RE: Trilogy Apartments
800 & 810 NW Ward Rd
Lee's Summit, MO
Building "2"
Exterior Door Threshold Compliance

Exhibit 3: Pet Spa & Bike Storage/Mini Market

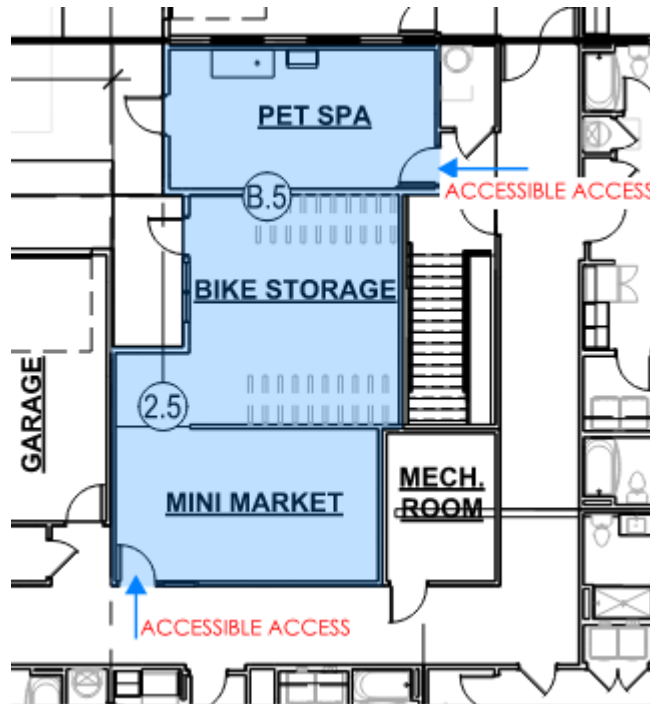
Locations #3 & #4: Pet Wash Room and Bike Storage/Mini Market Room

Similarly to Location #2, these two doors can be considered convenience doors for these two rooms rather than required accessible doors.

Both of these spaces have accessible access within the building as is shown in the exhibit below.
